**TITLE : AIR CONDITIONING - AVIONICS VENTILATION - INSTALL A DRAINAGE
DOWNSTREAM OF THE BLOWER FAN.**

**This page transmits Revision No. 07 of Service Bulletin
No. A320-21-1078.**

**Revision No. 07 is issued to inform the affected customers that subject
Service Bulletin is superseded by Service Bulletin No. A320-21-1113
(Mod. No. 27296P5350).**

SERVICE BULLETIN No. : A320-21-1078

Kit A01
In Avionics Compartment, Zones 127 and 128,
Modification of Blowing Duct
Figure 1

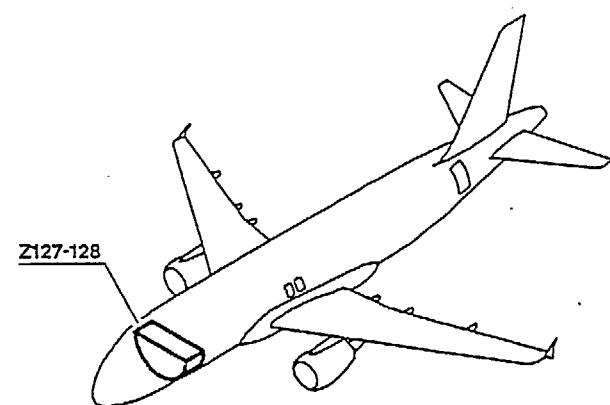
- (1) Removal of the blowing duct in zones 127 and 128

(a) Remove :

1 clamp	Item (4) (discard)
1 O-ring	Item (3) (discard)
1 blowing duct	Item (1) (discard)

(a) Put in position as shown on Detail B and install :

1 blowing duct	D2121155600000	Item 1
1 O-ring	NSA8203-264	Item 3
1 clamp	NSA8603-837	Item 4

Kit A01
In Avionics Compartment, Zones 127 and 128,
Modification of Drain System
Figure 2

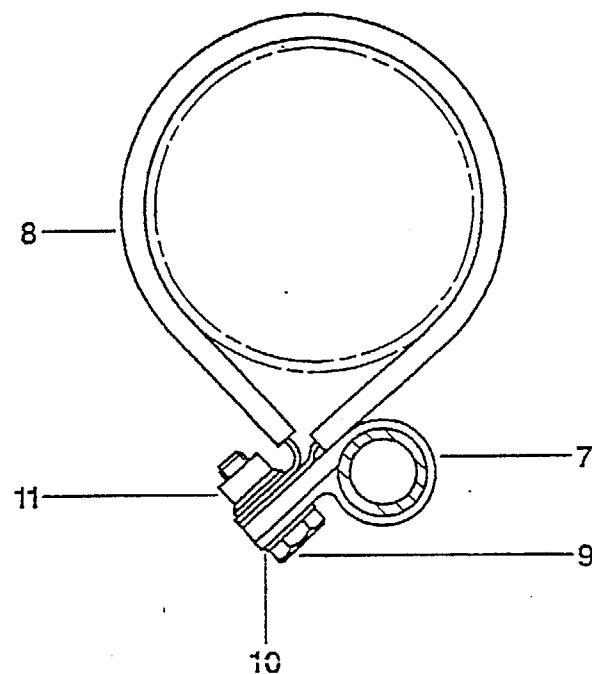
(2) Modification of the drain tube in zones 127 and 128

(a) Install as shown in Detail A :

(b) Put in position the tee union and cut the drain tube to a length of :

300 mm (12 in.).

(a) Put in position as shown on Detail A and install :

1 clamp	NSA5516-64NS	Item 8
1 clamp	NSA5515-10	Item 7
1 screw	NAS1096-3-10	Item 9
1 washer	ASNA2397-10L	Item 10
1 nut	NSA5050-3	Item 11

Kit A02
In Avionics Compartment, Zones 127 and 128,
Installation of Blowing Duct and Cap
Figure 3

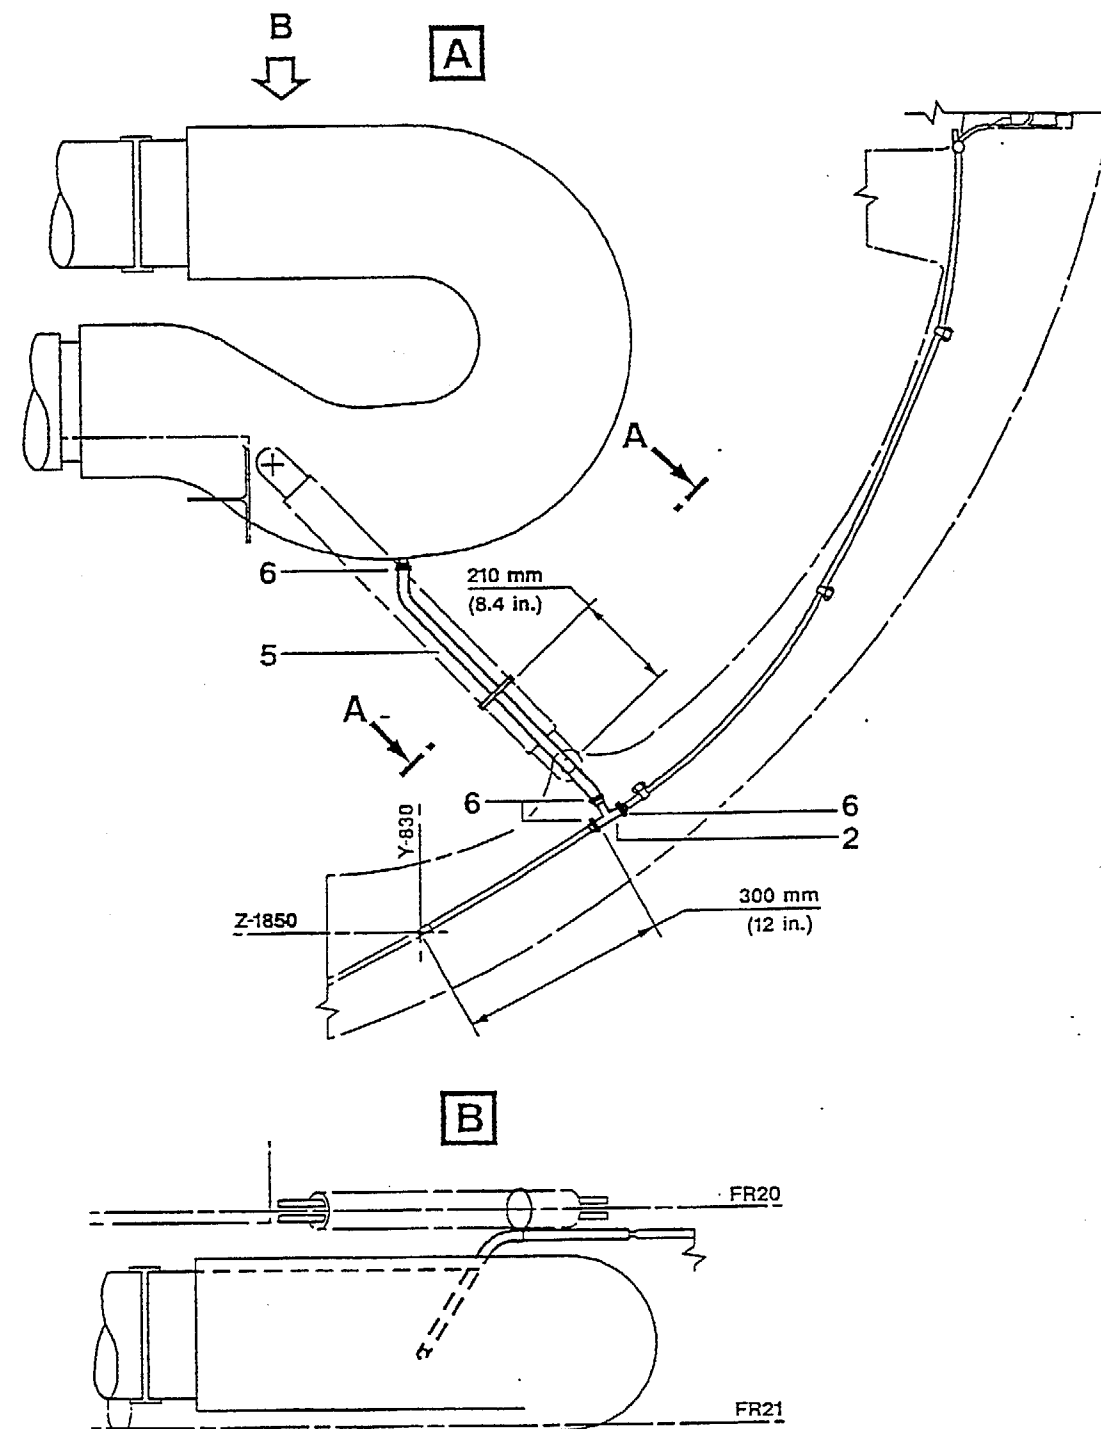
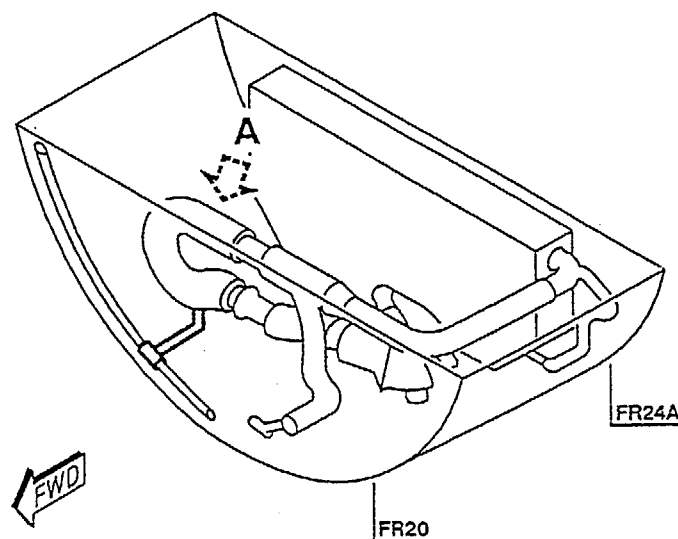
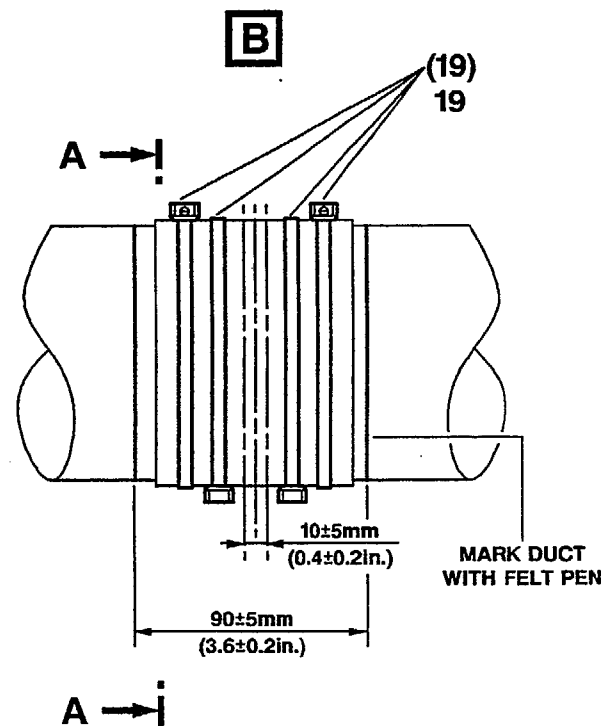
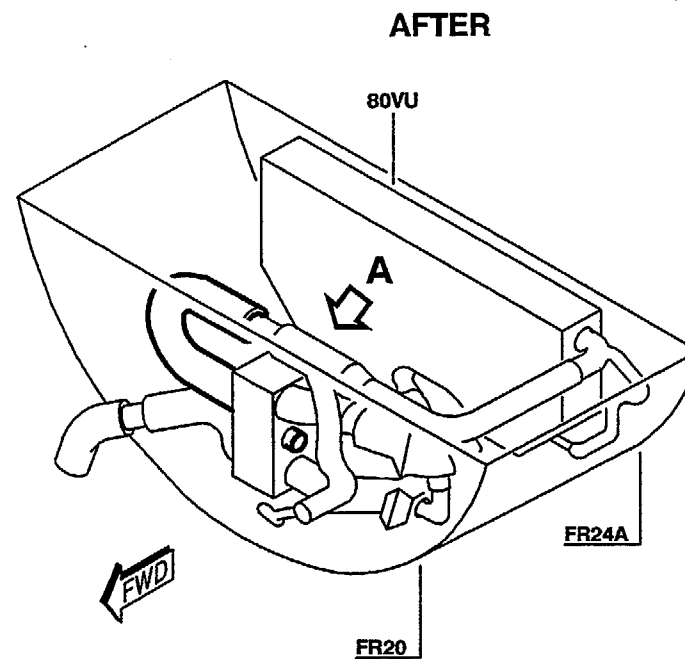
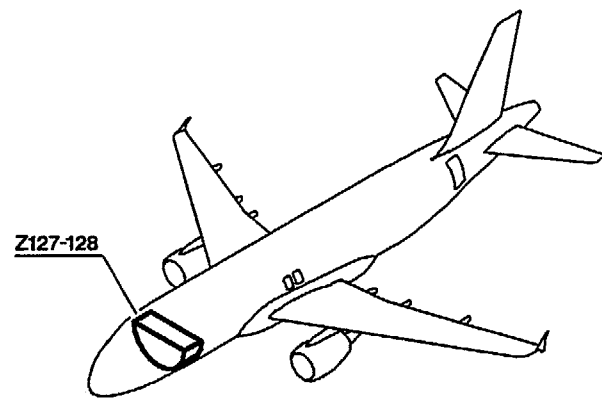
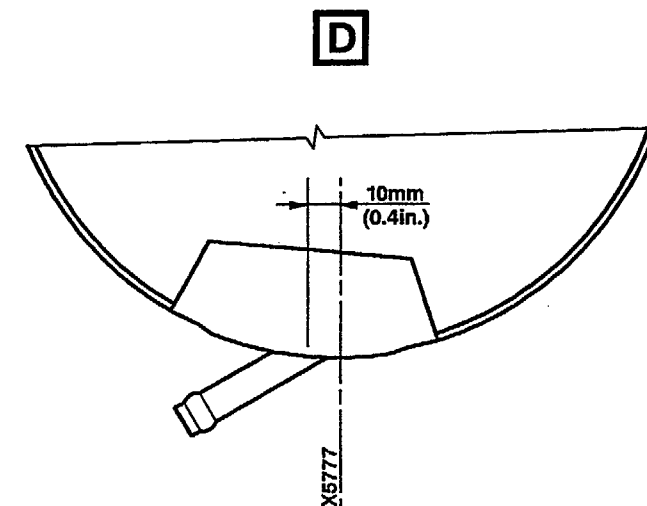
Refer to Figure 3, Details B and A

8 clamps

Item (19) discard

1 blowing duct

Refer to Figure 3, Details B and A

8 clamps NSA5528-180 Item 19
1 reworked blowing duct D2121163800000 Item 27

Refer to Figure 3, Details C and D

4 clamps NSA5528-200 Item 18
1 reworked cap D2121163500000 Item 28

Kit A02
In Avionics Compartment, Zones 127 and 128,
Modification of Blowing Duct and Cap
Figure 4

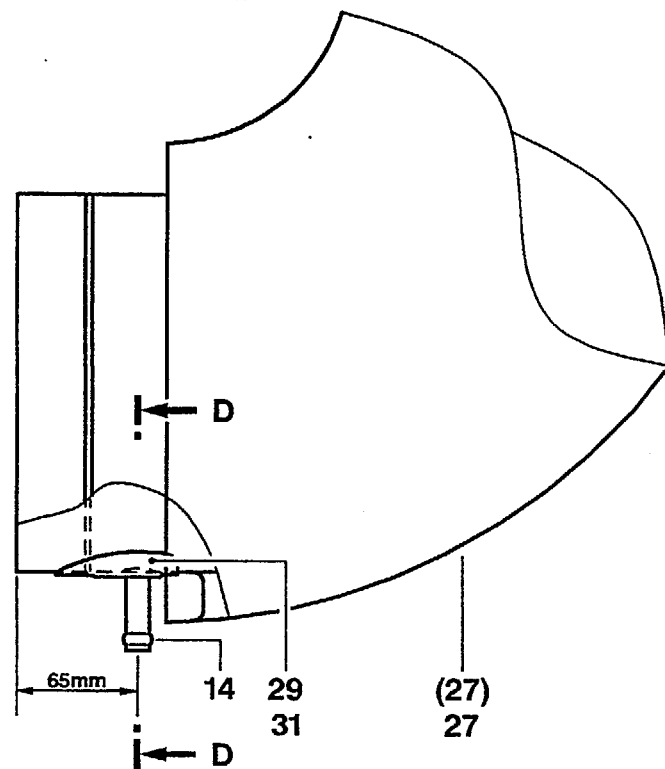
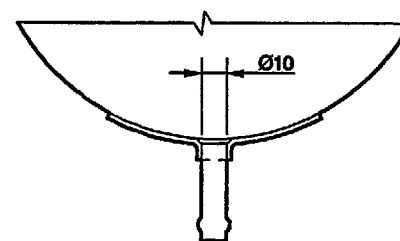
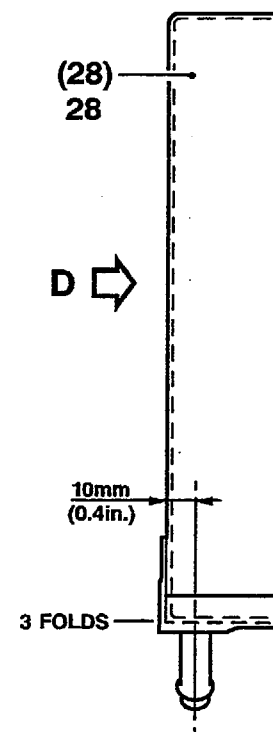
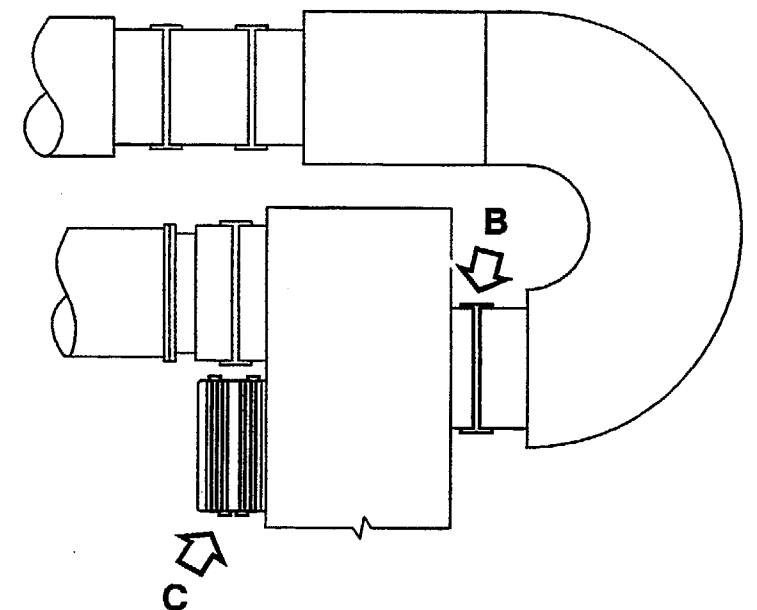
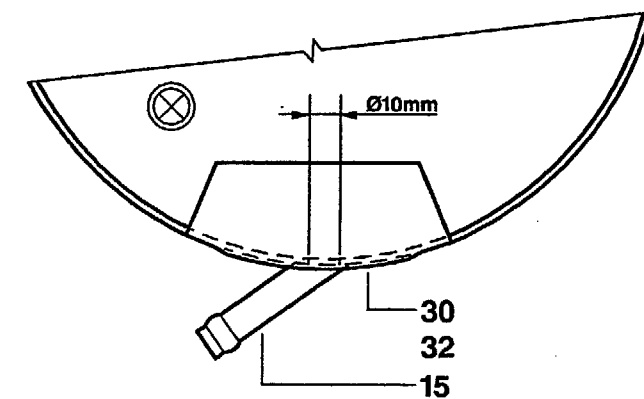
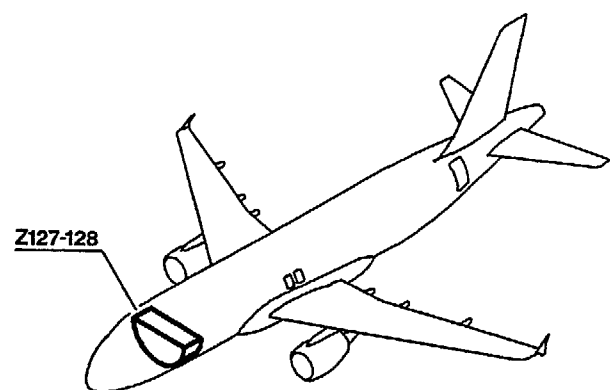
(a) Drill :

Refer to Figure 4, Detail B and Section D-D

With respect to the dimensions, mark and drill 1 hole to 10 mm (0.4 in.) dia.

1 union D2121163700000

(a) Drill :

Refer to Figure 4, Details C and D

With respect to the dimensions, mark and drill 1 hole to 10 mm
(0.4 in.) dia.

1 union D2121163400000 Item 15

with : 1 doubler made up of 3 plies of glasscloth Item 32
coated with cement phenolic Item 30.

Kit A02
In Avionics Compartment, Zones 127 and 128,
Modification of Drain System
Figure 5, Sheet 1 of 2

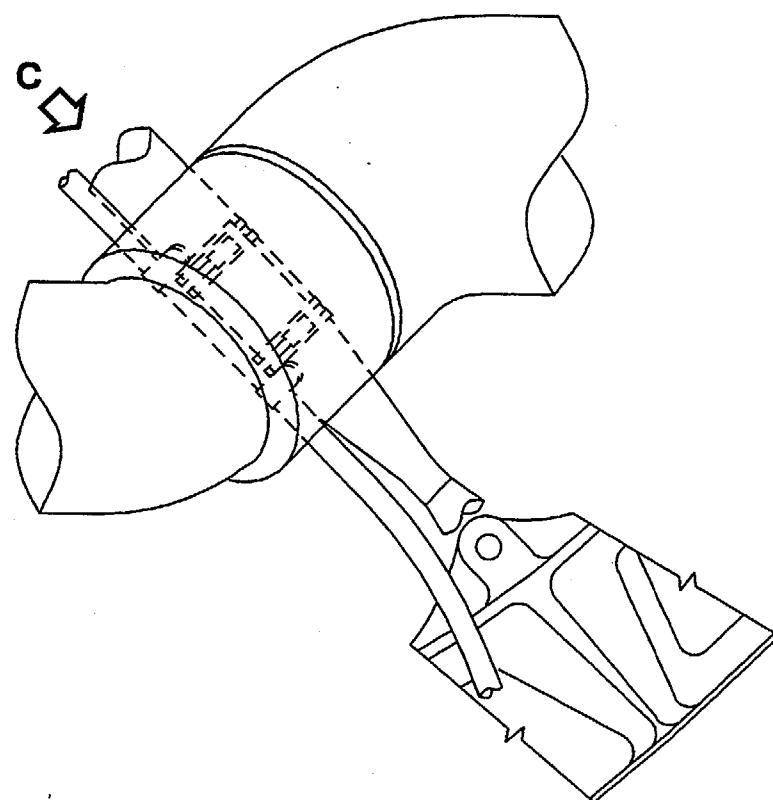
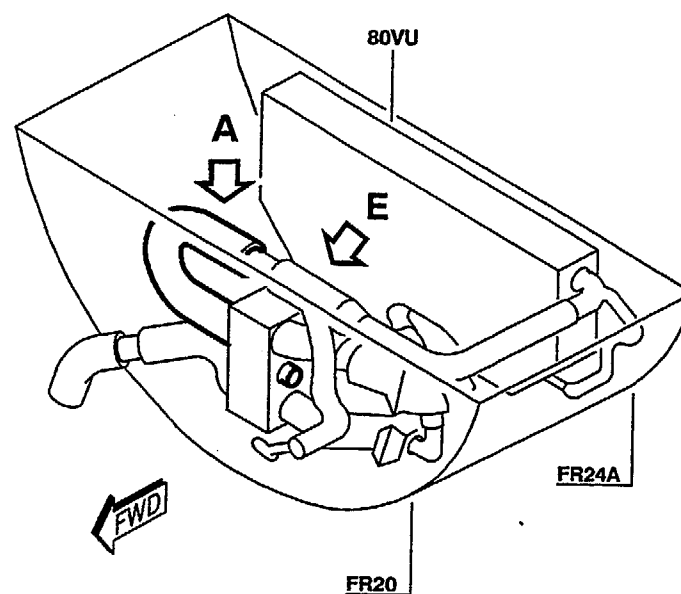
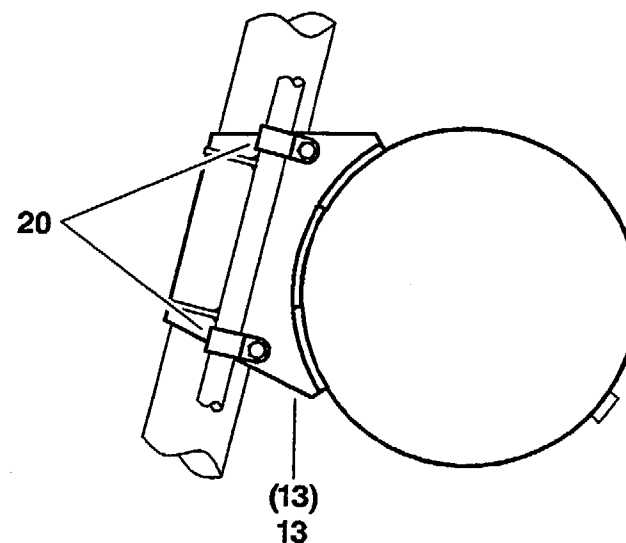
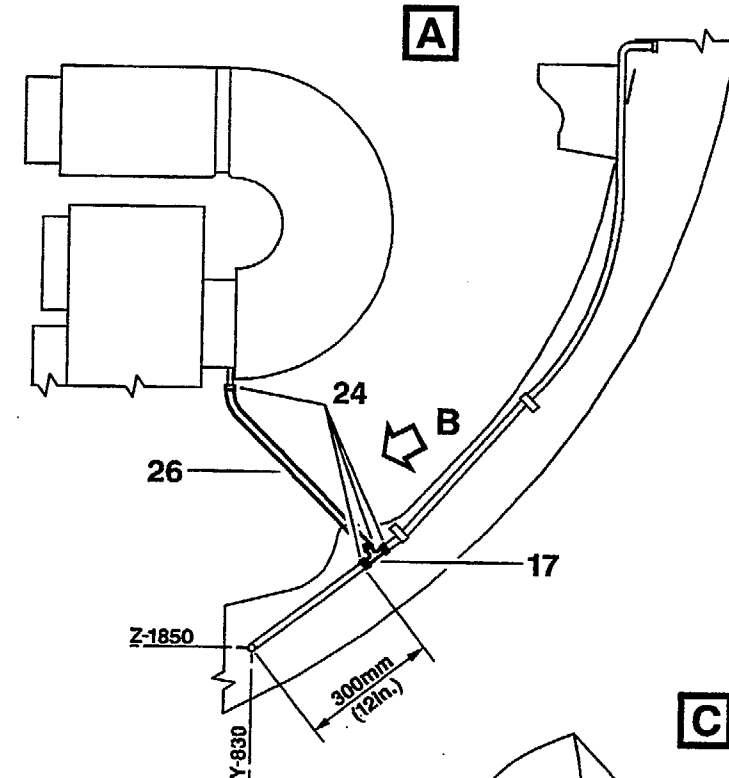
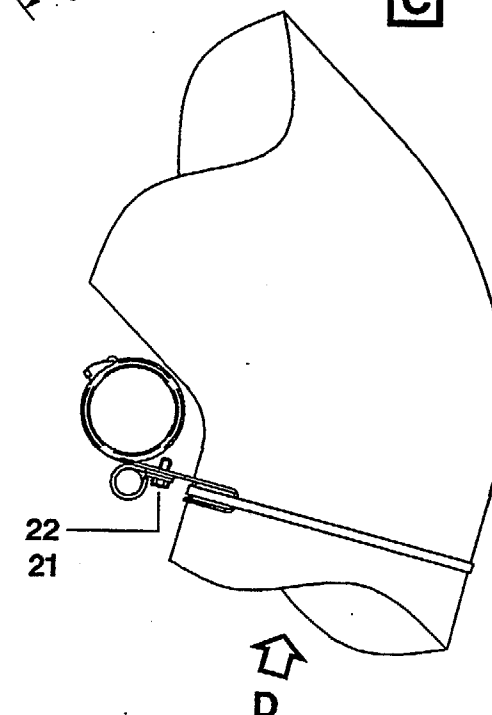
(a) Install :

Refer to Figure 5, Detail A

1 tee union D0003002400000 Item 17

(b) Put in position the tee union Item 17 and cut the drain tube to a length of 300 mm (12 in.).

(a) Put in position and install :

Refer to Figure 5, Details B, C and D

2 clamps	NSA5515-11	Item 20
2 screws	NAS1096-3-9	Item 21
4 washers	ASNA2397-10L	Item 22

Kit A02
In Avionics Compartment, Zones 127 and 128,
Modification of Drain System
Figure 5, Sheet 2

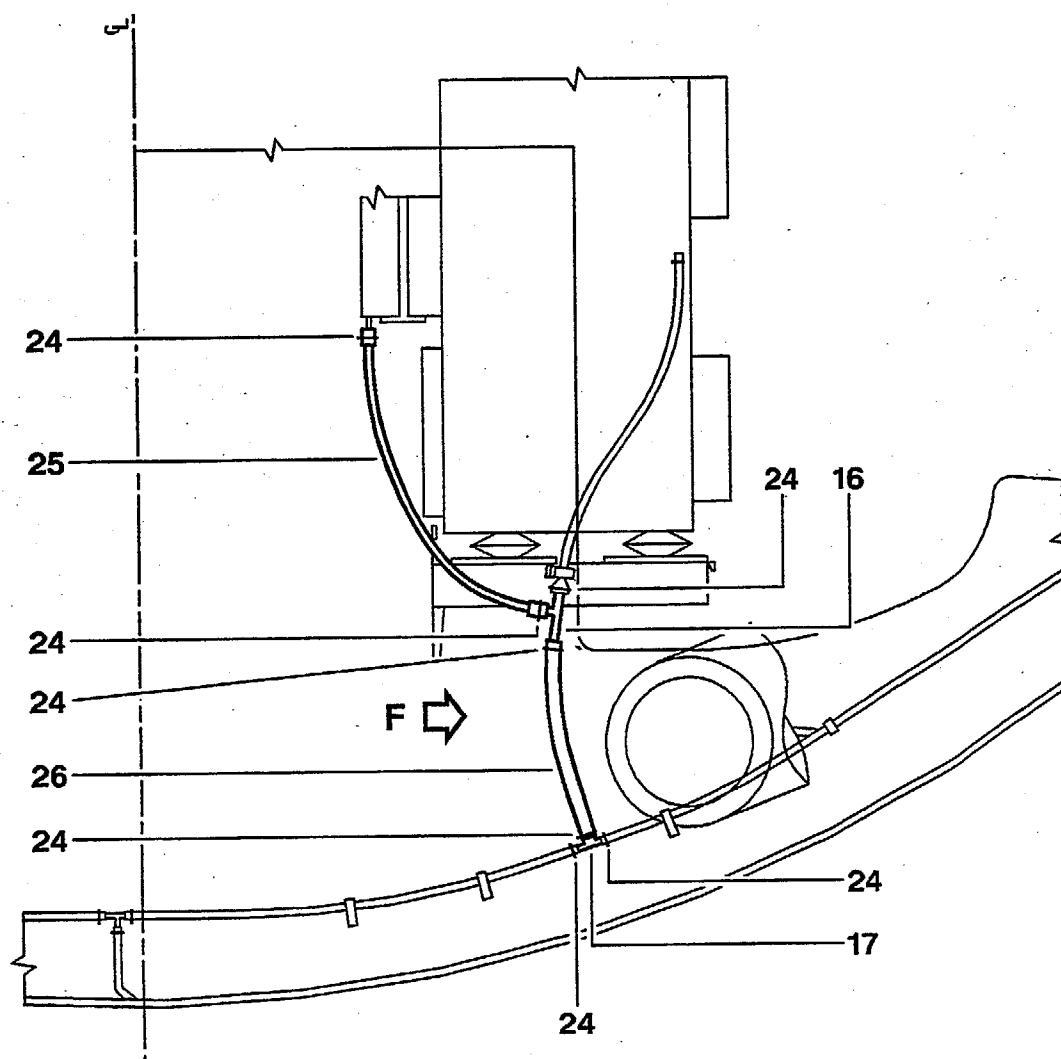
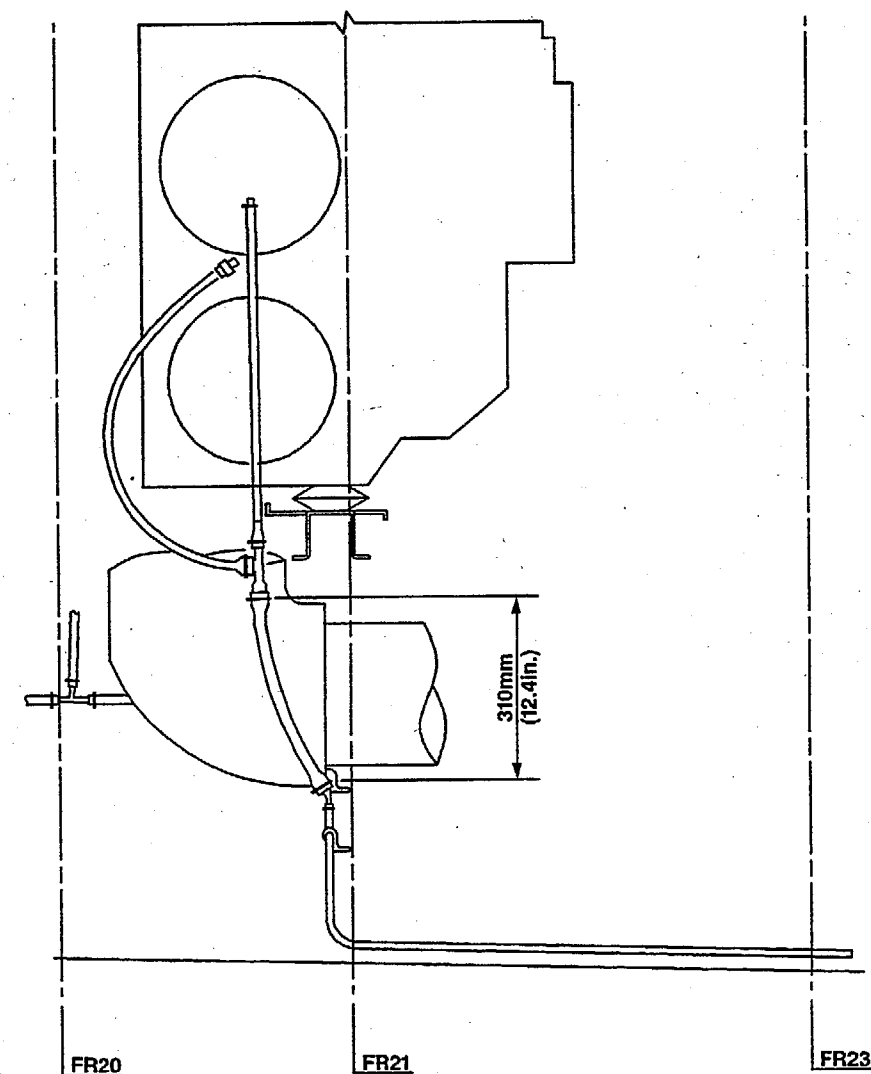
Refer to Figure 5, Details E and F

1 tee union D0003002400000 Item 17

1 tee union D0003003100000 Item 16

(e) Put in position the tee union Item 16 and cut the drain tube Item 26 to a length of 310 mm (12.4 in.).

Refer to Figure 5, Details E and F

1 tube	NSA3629-8-12	Item 25
2 clamps	ASNA0033-019	Item 24
